# PIER 70 MIXED-USE DISTRICT PROJECT

**CITY AND COUNTY OF SAN FRANCISCO  
PLANNING DEPARTMENT: CASE NO. 2014-001272ENV  
STATE CLEARINGHOUSE NO. 2015052024**

DATE: August 9, 2017  
TO: Members of the Planning Commission and Interested Parties  
FROM: Lisa Gibson, Environmental Review Officer  
Re: **Attached Responses to Comments on Draft Environmental Impact Report Case No. 2014-001272ENV: Pier 70 Mixed-Use District Project**

# PIER 70 MIXED-USE DISTRICT PROJECT RESPONSES TO COMMENTS

(REVISED) FIGURE 4.P.1: SAMPLE LOCATIONS AND AREAS OF IDENTIFIED IMPACT

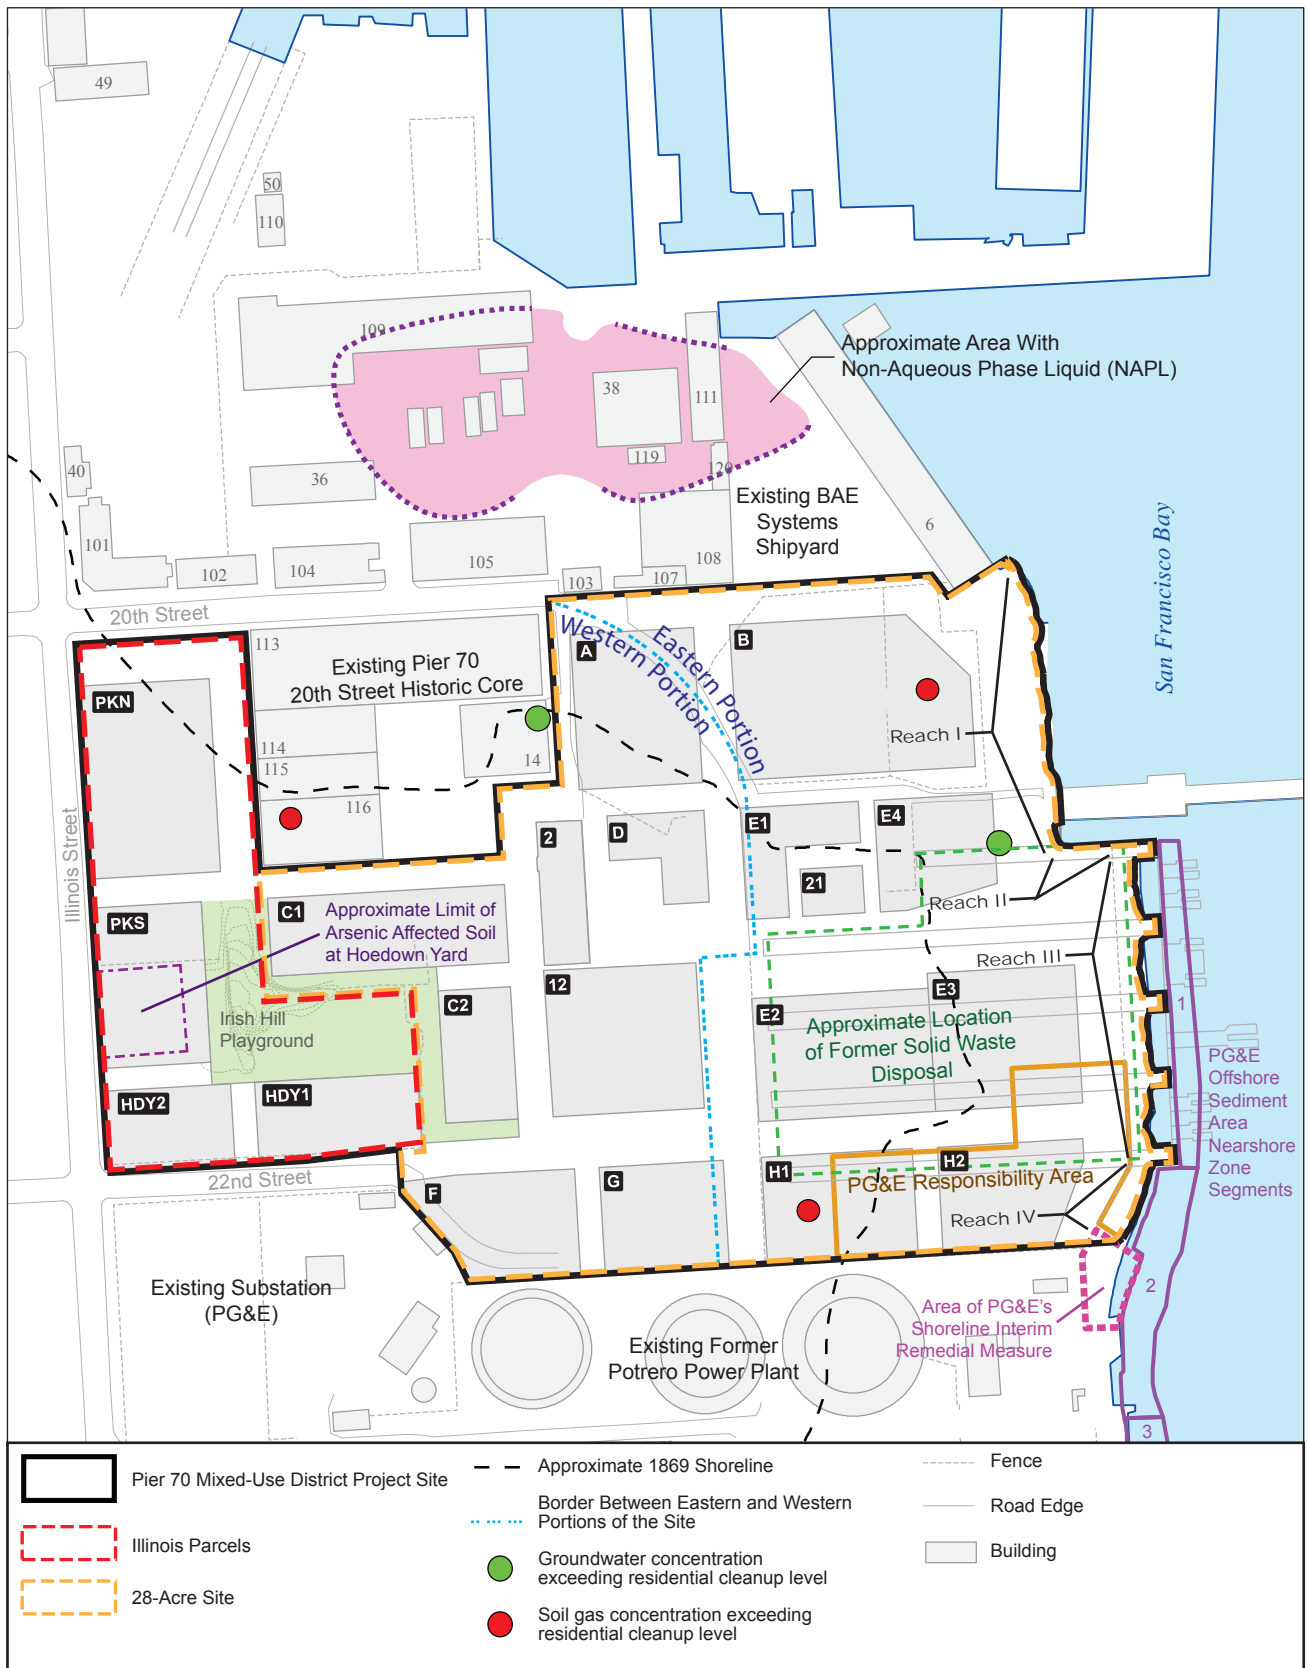
Only Reaches III and IV of the Proposed Project's shoreline improvements are located adjacent to PG&E's Offshore Sediment Area, as shown on (Revised) Figure 4.P.1: Sample Locations and Areas of Identified Impact, RTC p. 4.P.10. Reach I of the shoreline improvements is to the north of PG&E's Offshore Sediment Area. Reach II includes the bulkhead wall on the north of the slipway structures; this reach is to the west of PG&E's Offshore Sediment Area Segment 1. Reach III extends along the full length of Segment 1. All of Reach IV is located adjacent to the northern portion of PG&E's Offshore Sediment Area Segment 2 and also includes part of PG&E's Interim Remedial Measure implemented in 2010. However, there would only be a potential for overlap with the Offshore Sediment Area in Reach IV, as discussed below.

Figure 4.P.1: Sample Locations and Areas of Identified Impact, on EIR p. 4.P.3, has been revised to show the location of PG&E's Interim Remedial Measure and Reaches I through IV of the shoreline improvements proposed under the Pier 70 Mixed-Use District Project. The revised figure is shown on RTC p. 4.P.10.

The discussion on EIR pp. 4.P.34-4.P.35 is based on documents publicly available at the time the EIR was published. As presented below, this text has been revised to more clearly state how the shoreline improvement reaches overlap with PG&E's remediation segments; to reflect implementation of the Interim Remedial Measure noted by Comment A-PGE-5 (see RTC p. 4.O.6); and to describe the February 2017 remediation plan for the offshore sediments which was subsequently received from PG&E. Figure 4.P.1: Sample Locations and Areas of Identified Impact, on EIR p. 4.P.3, has also been revised to show the location of the Interim Remedial Measure, and Reaches I through IV of the shoreline improvements proposed under the Pier 70 Mixed-Use District Project. The revised figure is shown on the following page.

(NEW) FIGURE 6.1: IRISH HILL PASSAGWAY VARIANT

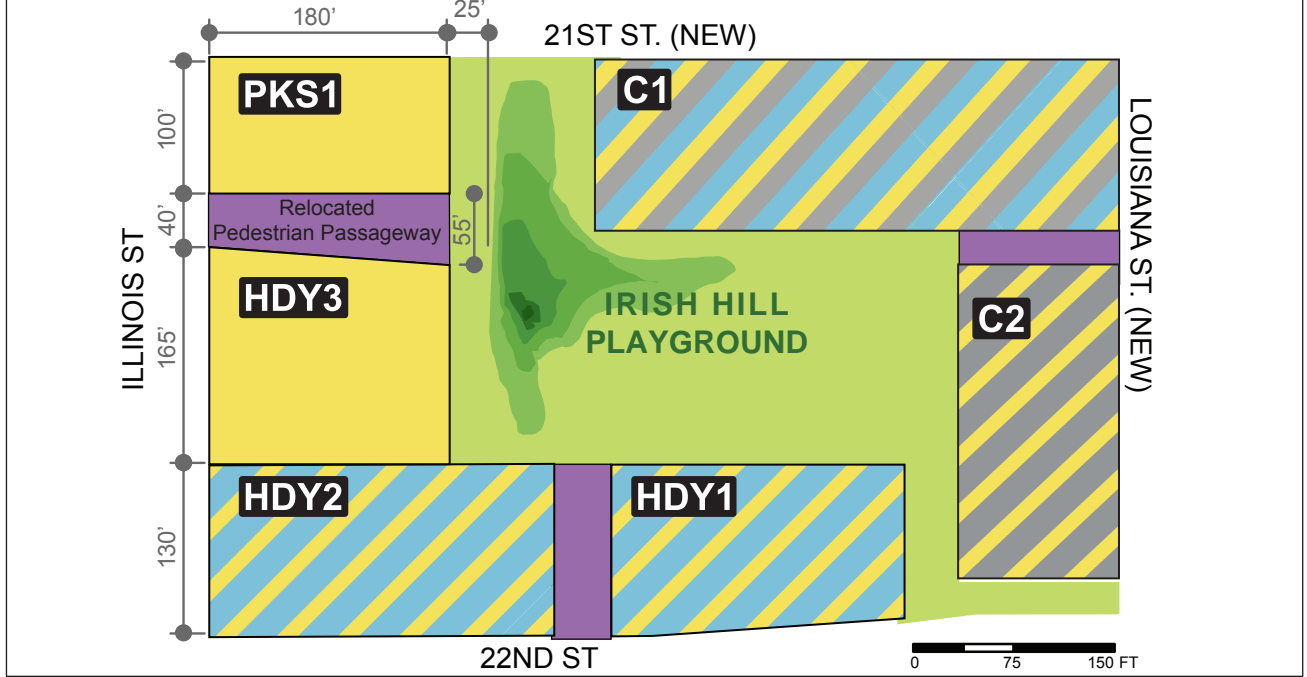
The purpose of the Irish Hill Passageway Variant is to realign the proposed pedestrian passageway between Illinois Street and the proposed Irish Hill Playground in order to create a view corridor through proposed infill construction, from Illinois Street to the Irish Hill landscape feature.

Under the Irish Hill Passageway Variant, the pedestrian passageway would be shifted northward by approximately 165 feet, bisecting Parcel PKS (which would become PKS1 and HDY3 with this variant), and would widen from 40 feet at Illinois Street to 55 feet at Irish Hill Playground, to allow views of the western face of the Irish Hill remnant from Illinois Street. (See Figure 6.1: The Irish Hill Passageway Variant.)

(NEW) FIGURE 6.2: PROPOSED PROJECT SHADOW ON IRISH HILL PLAYGROUND AT 4:00 PM (PDT) ON THE SUMMER SOLSTICE

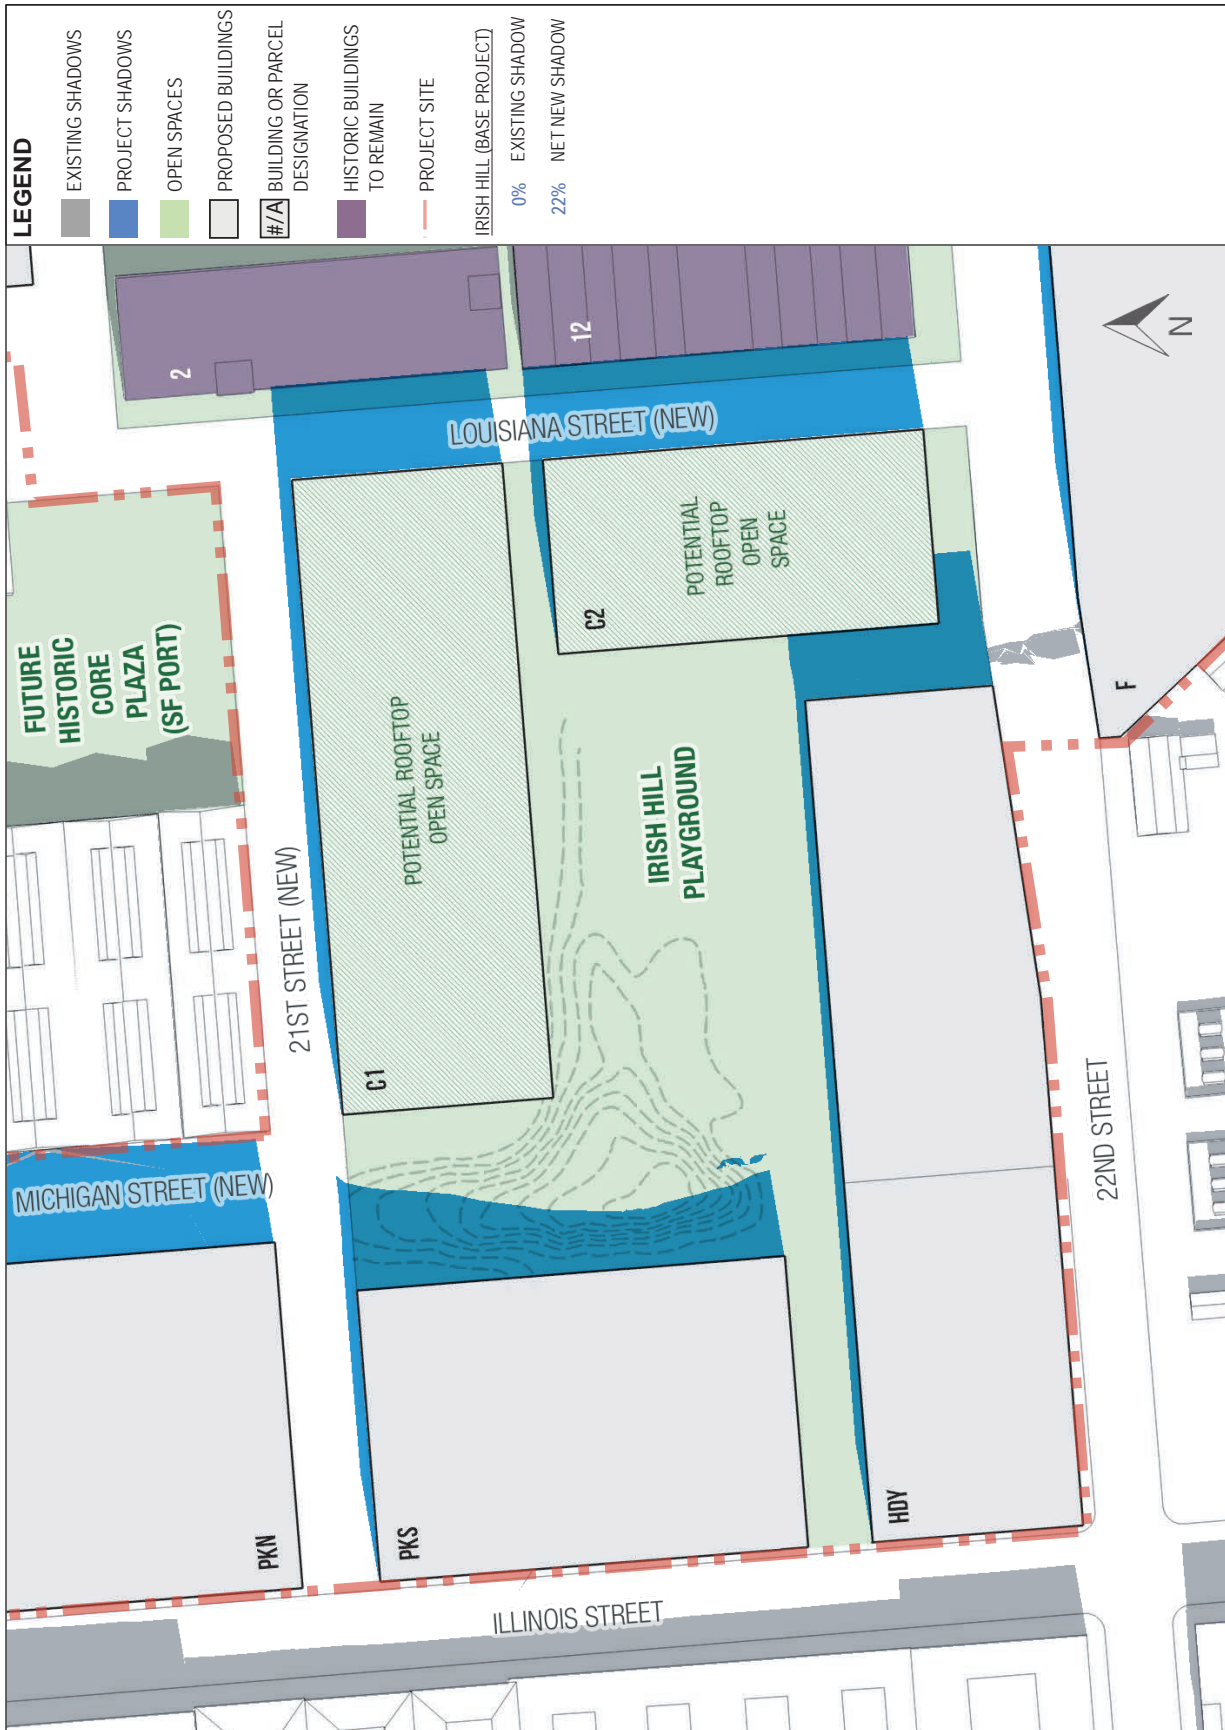
See Figure 6.2: Proposed Project Shadow on Irish Hill Playground at 4:00 PM (PDT) on the Summer Solstice. This figure shows the pedestrian passageway at the southern end of Parcel PKS in sunlight (the passageways are considered part of the open space). At this time of year and day, the sun aligns with the east-west orientation of the pedestrian passageway in the late afternoon. Figure 6.3: Irish Hill Passageway Variant Shadow on Irish Hill Playground at 4:00 PM (PDT) on the Summer Solstice shows the sunlit passageway shifted to the north. As the day progresses, the variant shadow on Irish Hill Playground, like the Proposed Project, would lengthen and sweep eastward and southward.

(REVISED) FIGURE 2.15: PROPOSED OPEN SPACE PLAN

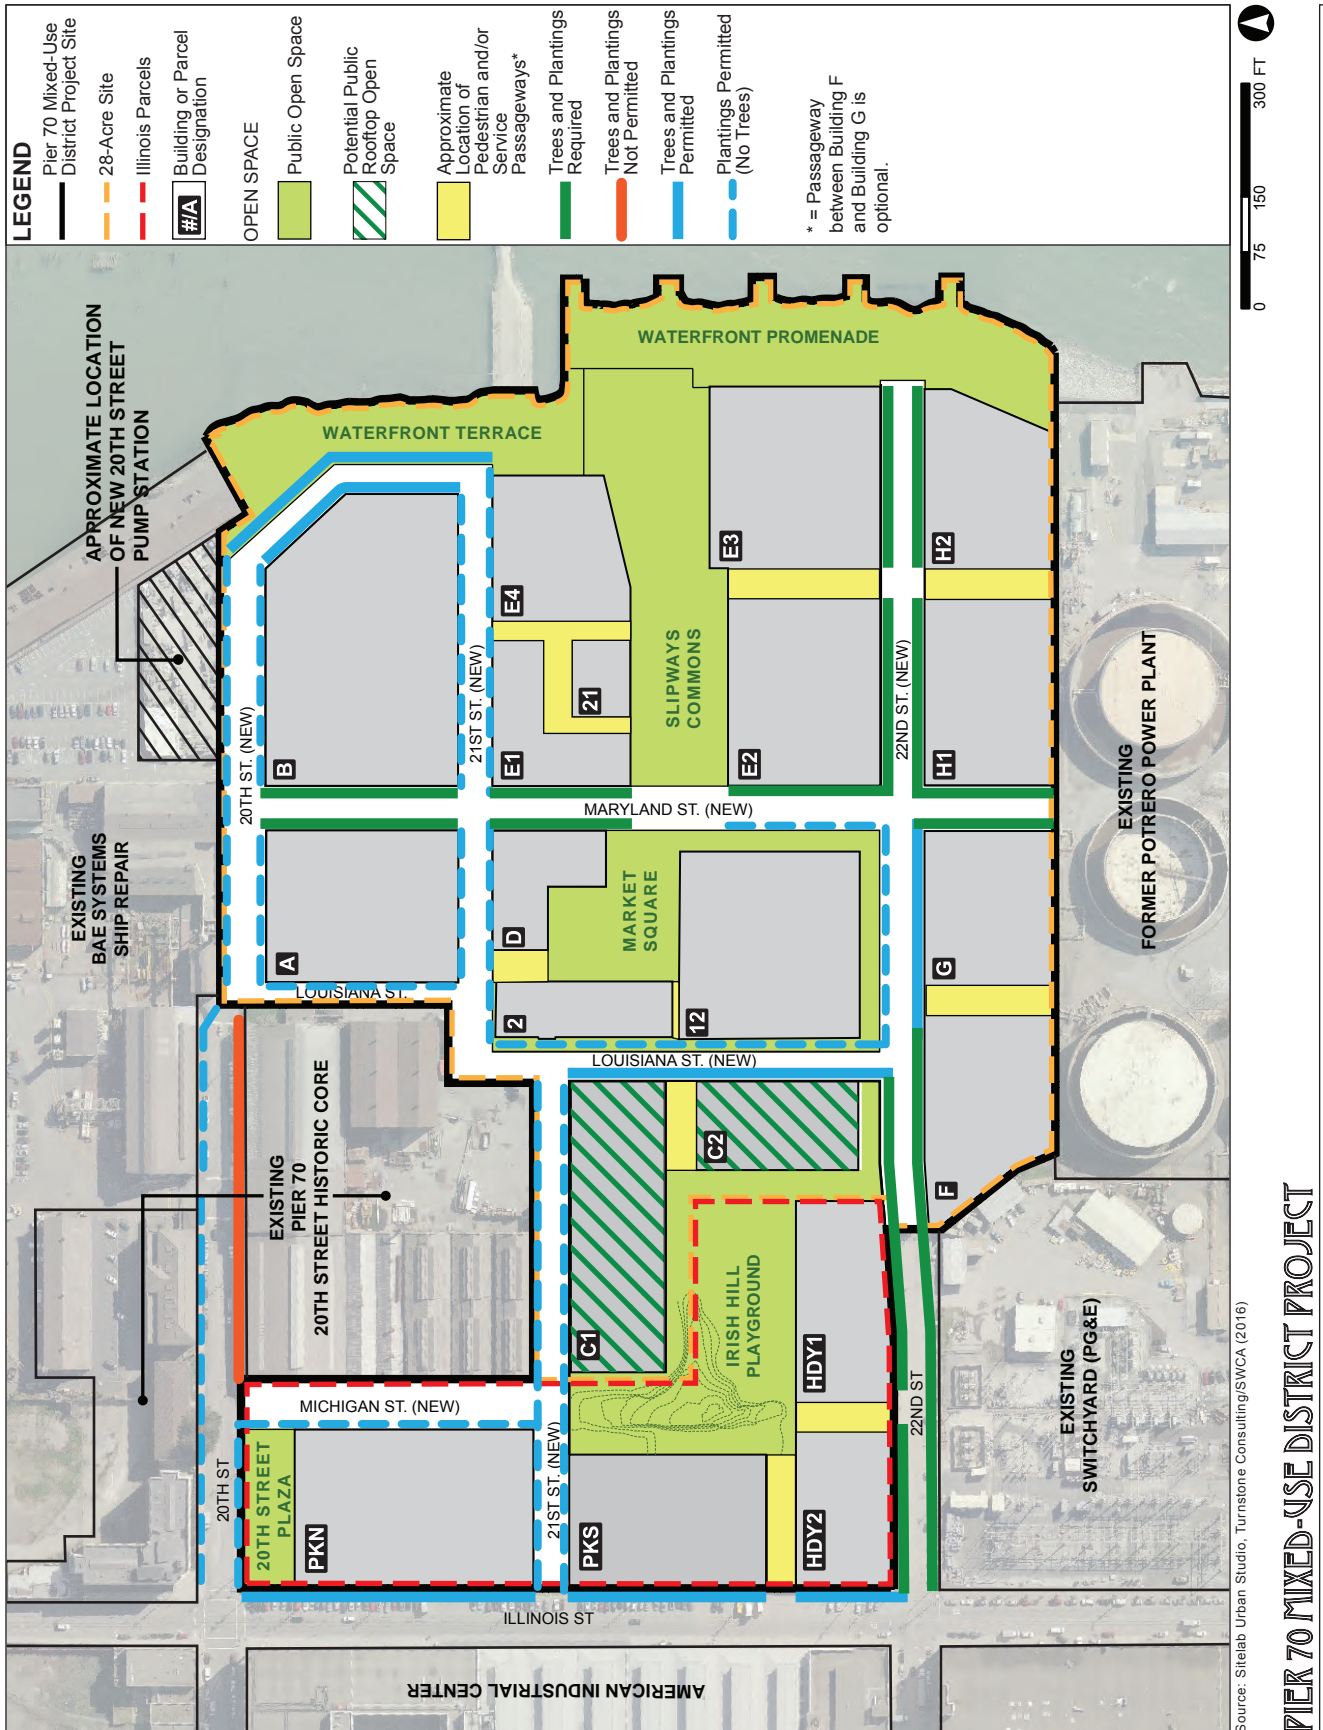
- \* Figure 2.15: Proposed Open Space Plan, on EIR p. 2.46, has been revised to reflect the changes to street tree locations, and its scale bar has also been revised. The revised figure is shown on RTC p. 5.33.
- \* To update the text to further expand upon the Proposed Project open space plan, two new paragraphs have been added after the paragraph under the heading “Rooftop Open Space Areas” on EIR p. 2.48, as shown below (new text is underlined). These revisions do not change any of the analyses or conclusions of the EIR.

(REVISED) FIGURE 2.16: PROPOSED ROADWAY NETWORK

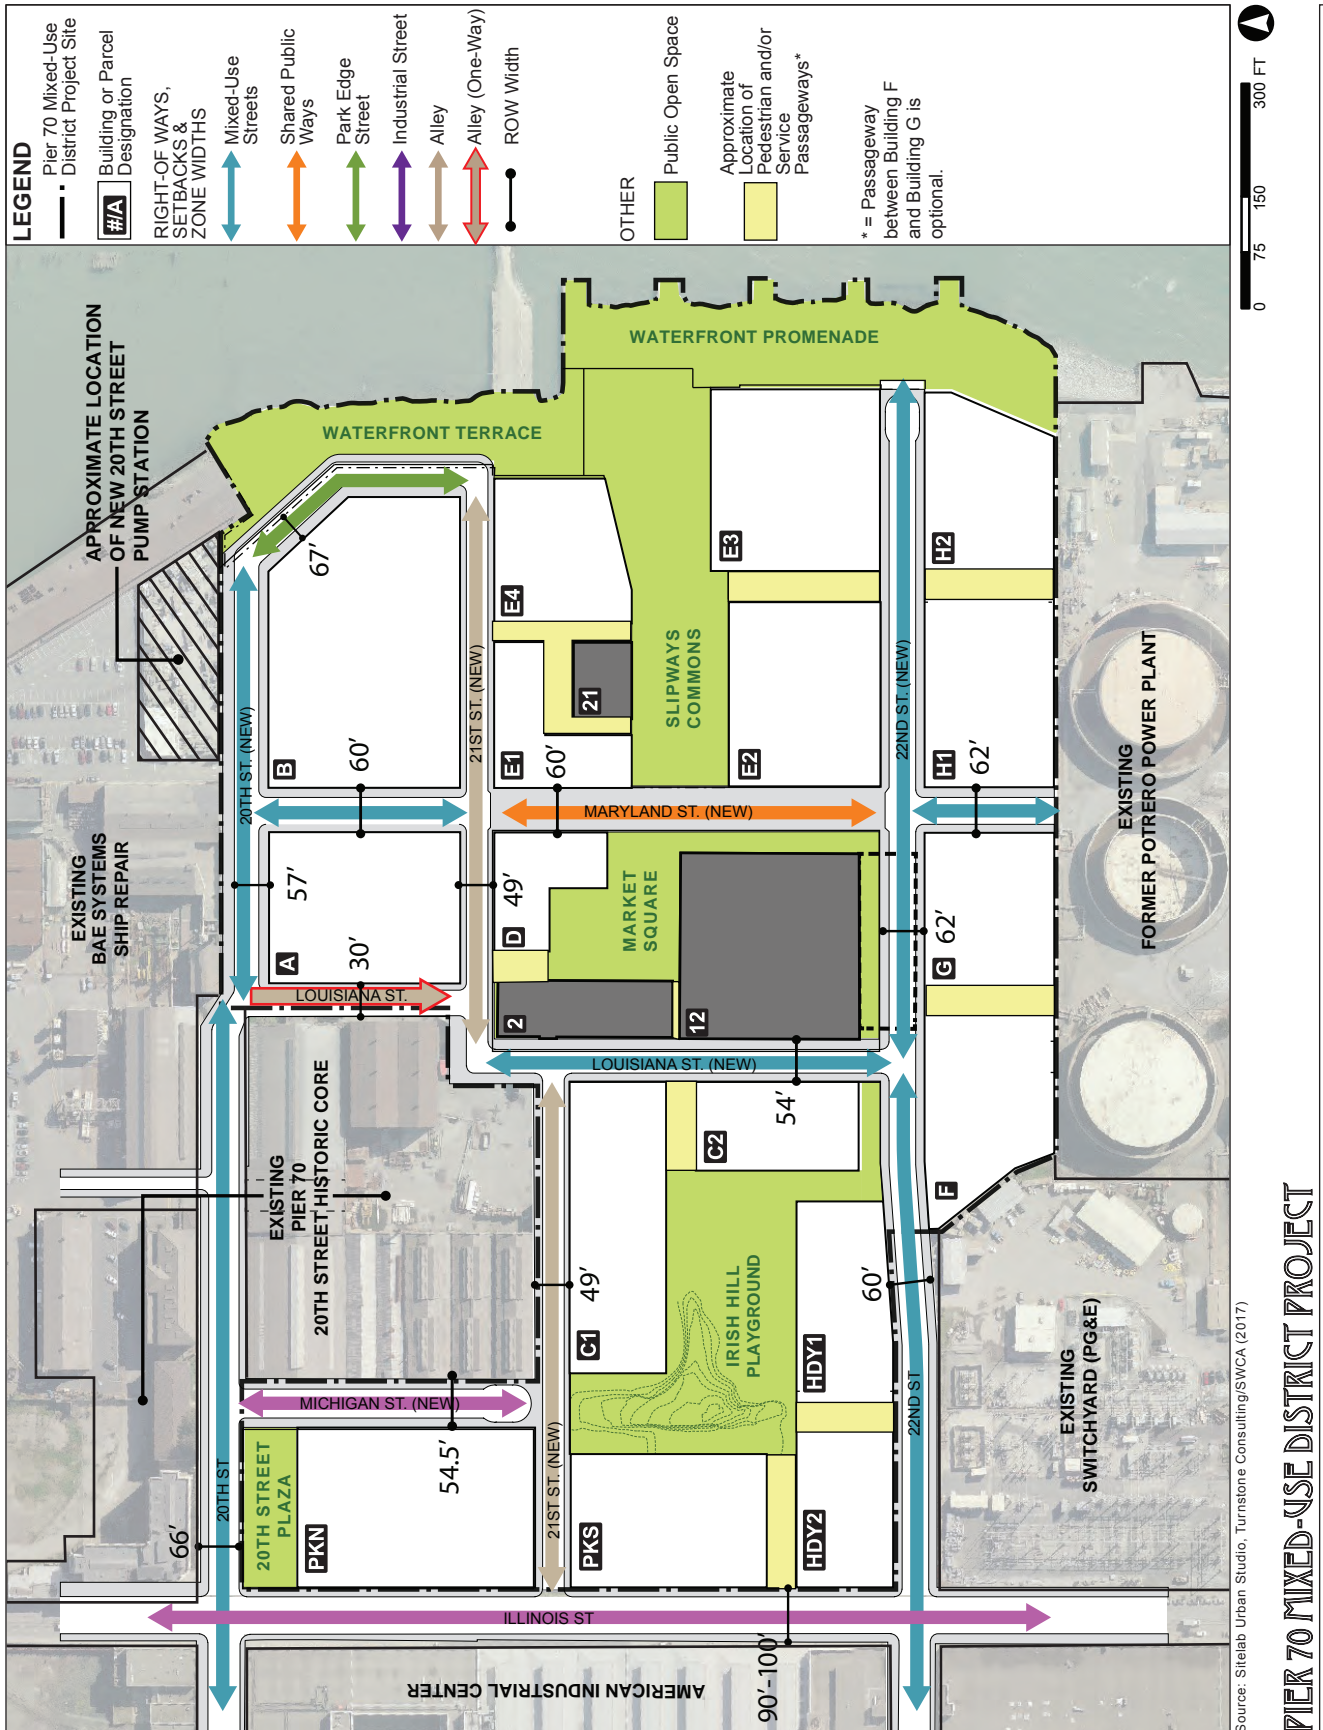
- \* Figure 2.16: Proposed Roadway Network, on EIR p. 2.50, has been revised to reflect the right-of-ways, setbacks, and zone widths established in the *Design for Development*, and its scale bar has also been revised. The revised figure is shown on RTC p. 5.34.
